County of Fairfax, Virginia

STAFF REPORT

**APPLICATION
DPA-HM-117-02,
PCA-B-846-03 and
PRC-B-846-04**

PROPOSAL: To amend the existing development plan DP-117 approved for a convention/conference center (office) to permit medium density residential to construct 54 single family attached dwelling units, including 5 workforce dwelling units.

COVER SHEET
 PRC PLAN/D.P.A./P.C.A.

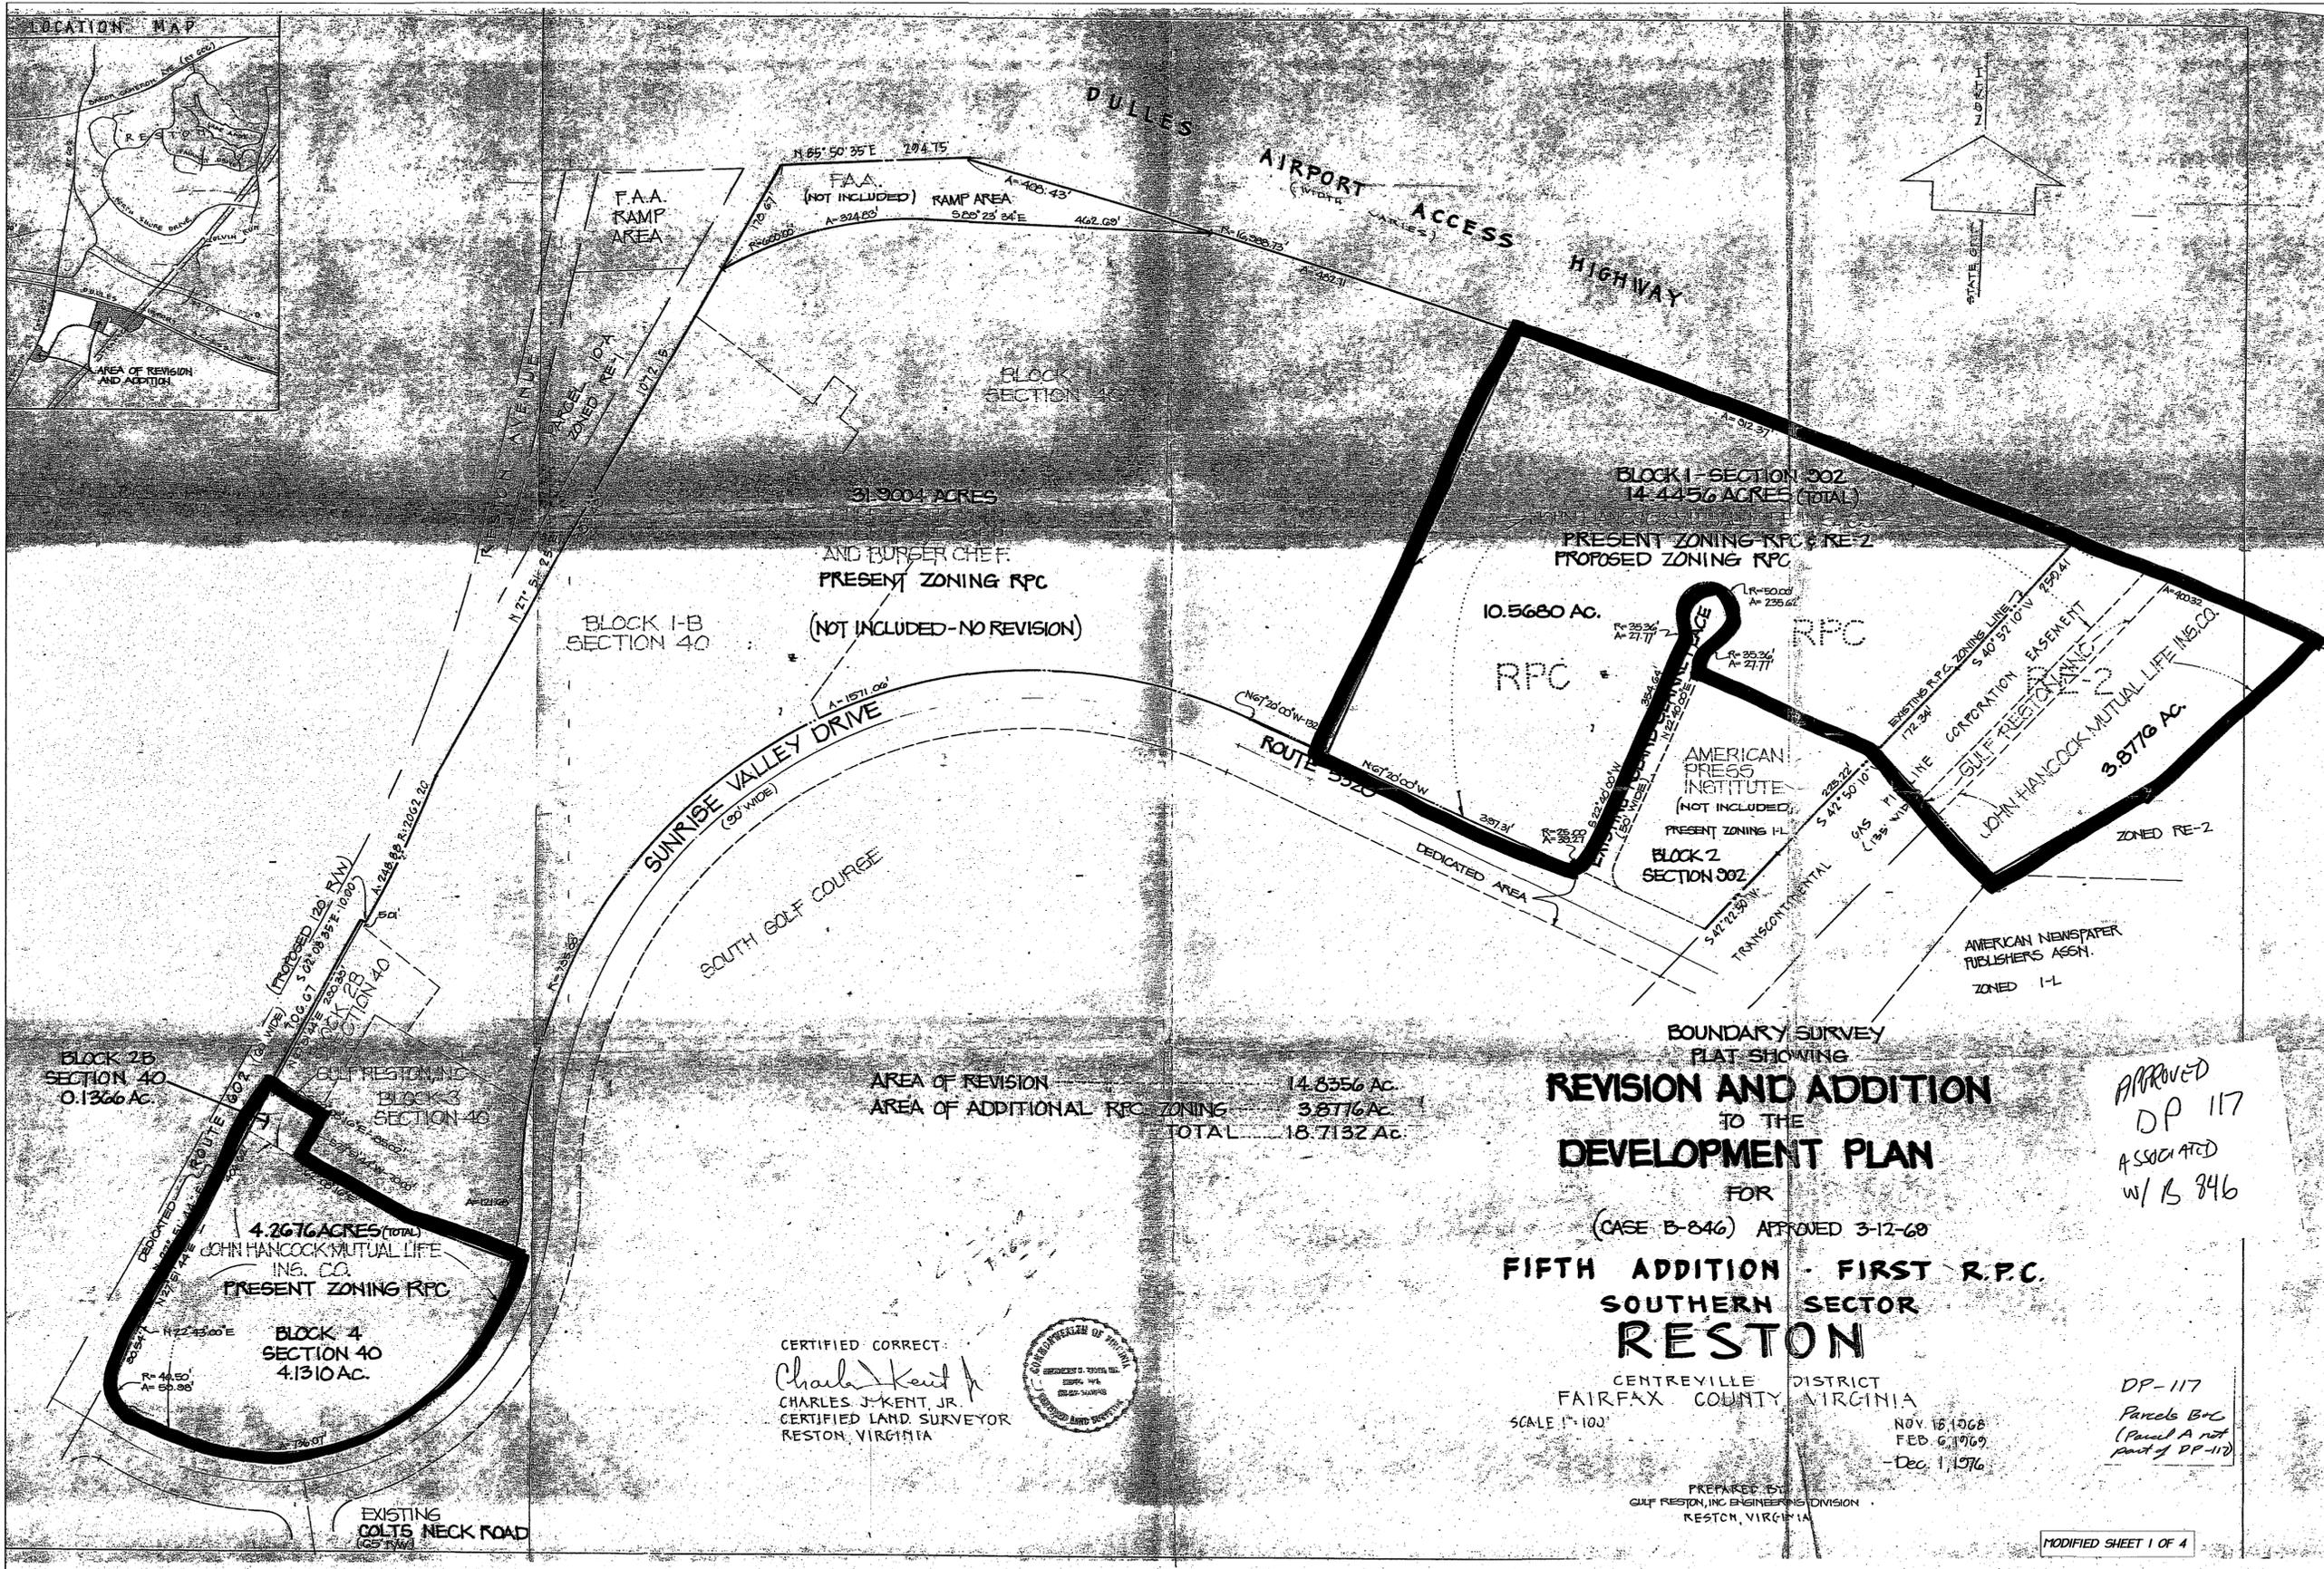
- Note 18 on Sheet 1 states "In accordance with the Fairfax County Trails Plan, a minor natural surface/stone dust trail 6' to 8' in width or a major paved trail 8' or greater is recommended along Sunrise Valley Drive". The Comprehensive Trails Plan, approved in 2014, depicts only a major paved trail (asphalt or concrete) that would be 8-foot or greater in width. Staff recommends the removal of the minor natural surface/stone dust trail language in order to be in compliance with the Trails Plan recommendation.

- Note 32 on Sheet 1 states that the Sunrise Valley Drive trail/cycletrack and the pedestrian amenity will either be maintained by Reston Association or the HOA. However these facilities have not been addressed in the proffer set reviewed by staff. The applicant should clarify and codify the maintenance responsibility for the Sunrise Valley Drive trail/cycletrack and the pedestrian amenity in the proffers.

- Note 20 on Sheet 1 of the plan states, "Roland Clarke Place is identified as an Enhanced Public Transportation Corridor in the Comprehensive Plan for future improvements". The Enhanced Public Transportation Corridor relates to the Dulles Toll Road. Staff believes this has been misinterpreted by the applicant and therefore recommends this note be removed from the plan.

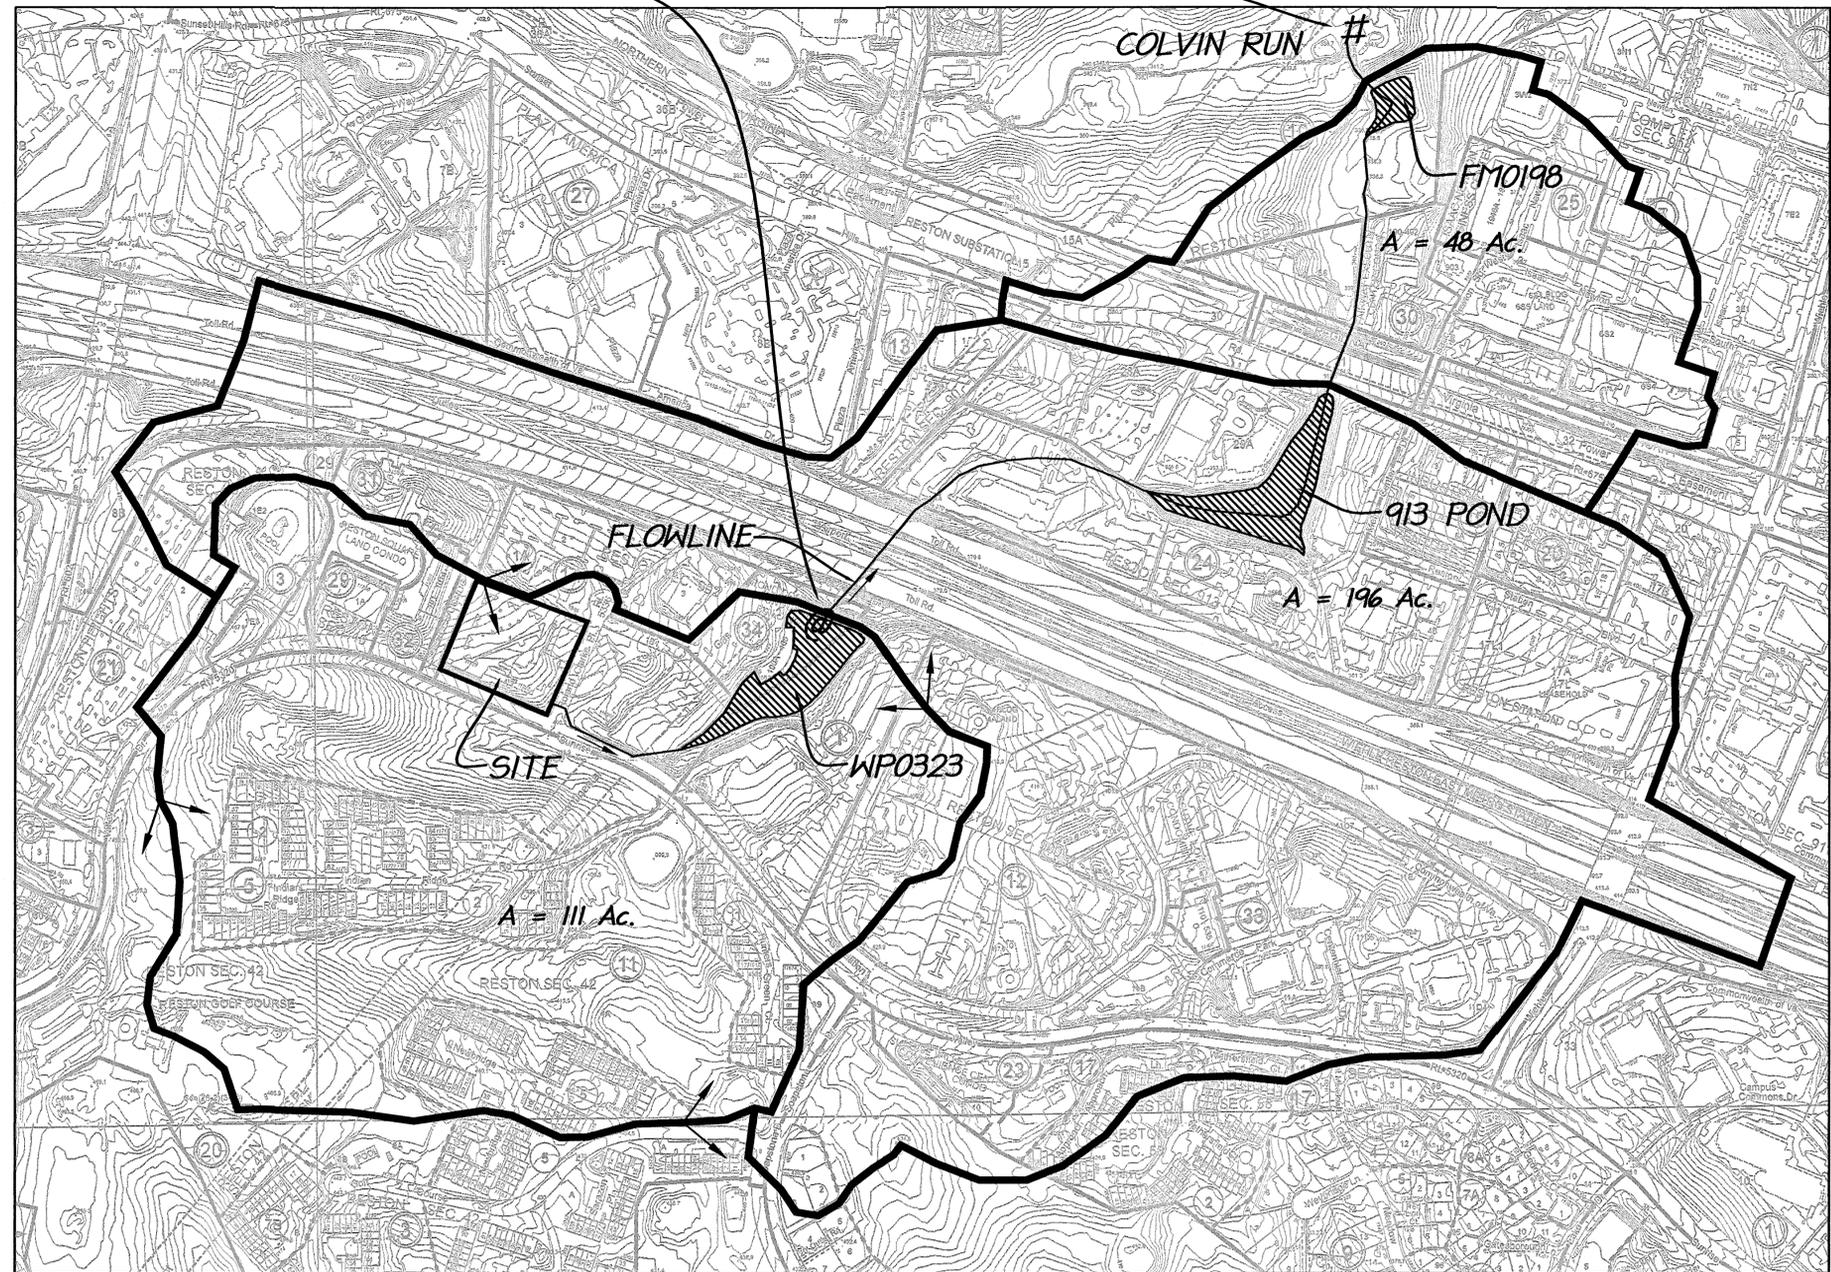
Adequacy of Outfall: The capacity of the downstream conveyance system which includes the 913 Pond (Sheet 8), the series of the culverts under Sunset Hill Road and the Washington and Old Dominion trail is inadequate, as evidenced by the frequent flooding. Maintenance and Stormwater Management Division (MSMD) commissioned a drainage study to assess and address the flooding situation. The outcome and the findings of the drainage study are

In order to mitigate the impact of increased flows, a proportional improvement must be demonstrated in order to reduce the flooding situation. Therefore, the extent of outfall analysis shall be extended to the existing culvert system under Sunset Hill Road per Sheet 8 of the subject plans. In addition, the applicant shall demonstrate that the subject development shall not exacerbate or worsen the flooding situation downstream. The outfall analysis for the subject site must adequately address flood protection downstream per Article 4 of the Stormwater Management Ordinance. In addition, the applicant shall demonstrate that a sufficient level of detention is provided on-site so that a reduction in the 100-year WSE is achieved upstream of the inadequate culvert under Sunset Hill Road.

Figure 2- Proposed DPA/PRC/PCA Layout (Source: Applicant, Sheet 3)

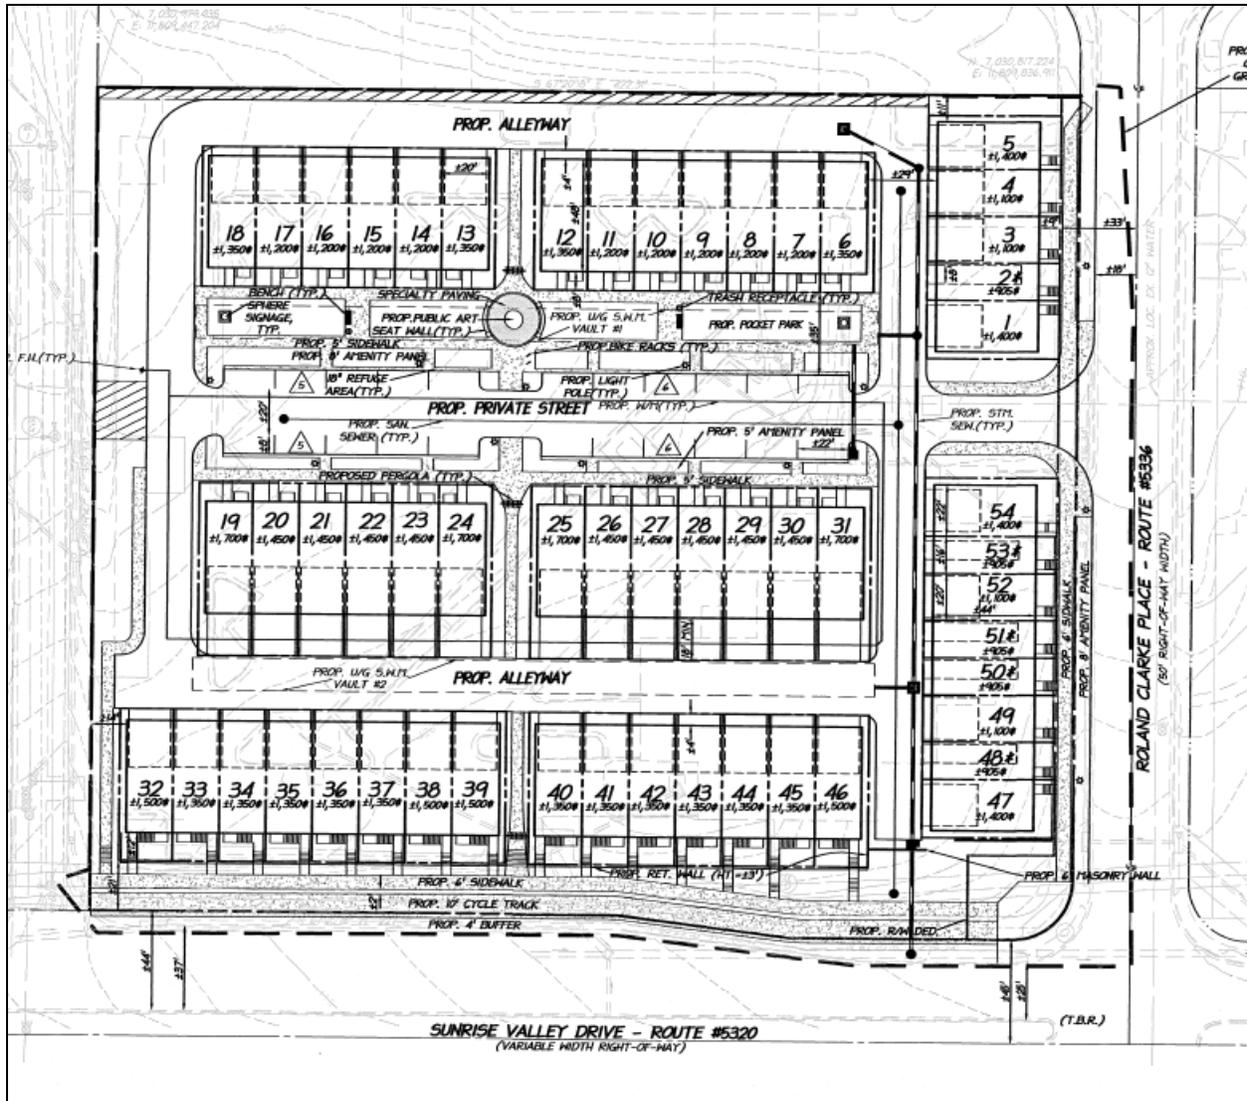
Staff noted that the previous site design resulted in unnecessary pavement more likely to be found in suburban developments rather than in urbanizing areas such as in envisioned for the Wiehle Station TOD District. The applicant revised their original site design to address staff concerns. The applicant deleted two dwelling units from the site plan, which in turn:

Figure 5- Proposed Garage Layouts (Source: DPA/ PCA/GDP, Sheet 5A)

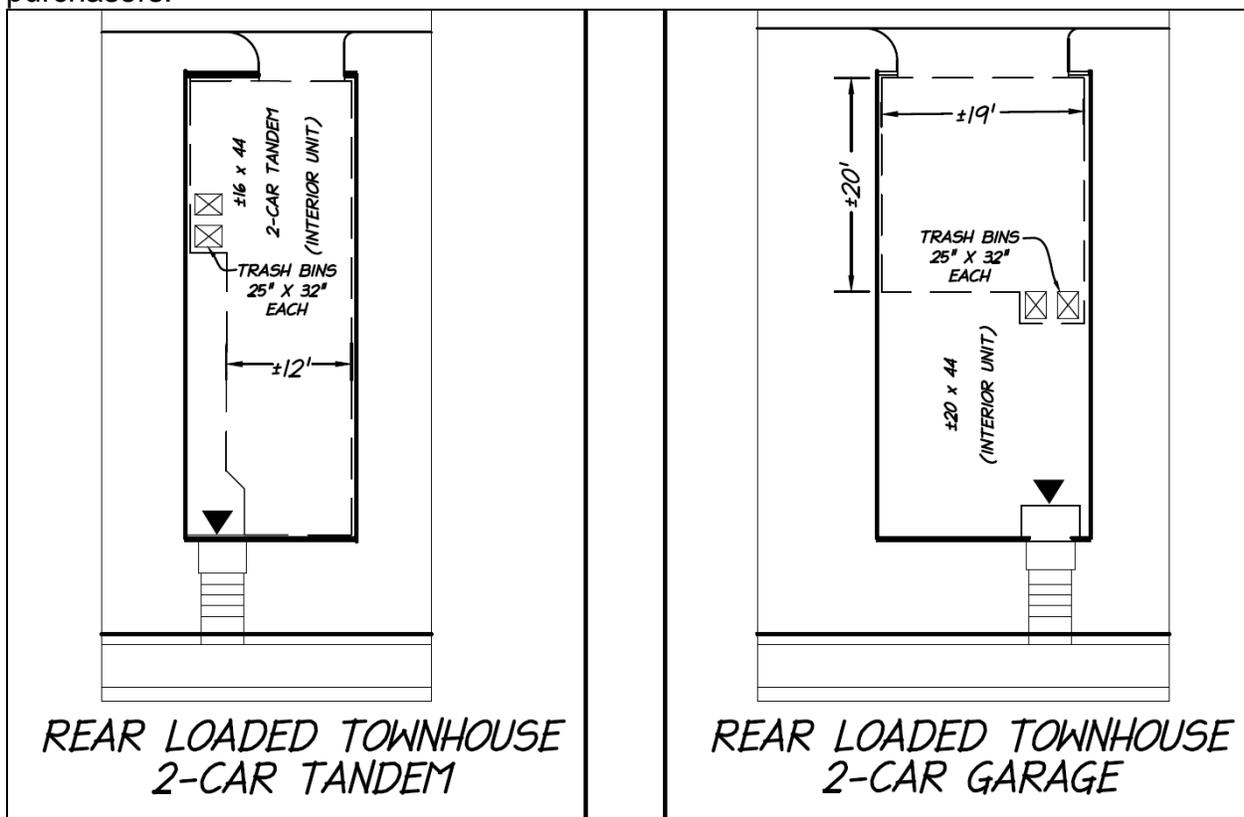
The garages are proposed to be 19 feet wide by 20 feet deep to allow parking for two vehicles (See Figure 5). The five proposed workforce dwelling units are proposed to have a total of two tandem parking spaces which are 16 feet wide and 44 feet deep. For all garages, space has been provided for the storage of two trash cans and the HVAC units are to be located on the roofs, so they will not interfere with the ingress and egress of vehicles to the dwellings. The applicant has proposed a proffer that the garages will only be used for purposes that do not interfere with vehicle parking, and this information will be disclosed in the future HOA/COA documents and shall be told to prospective purchasers.
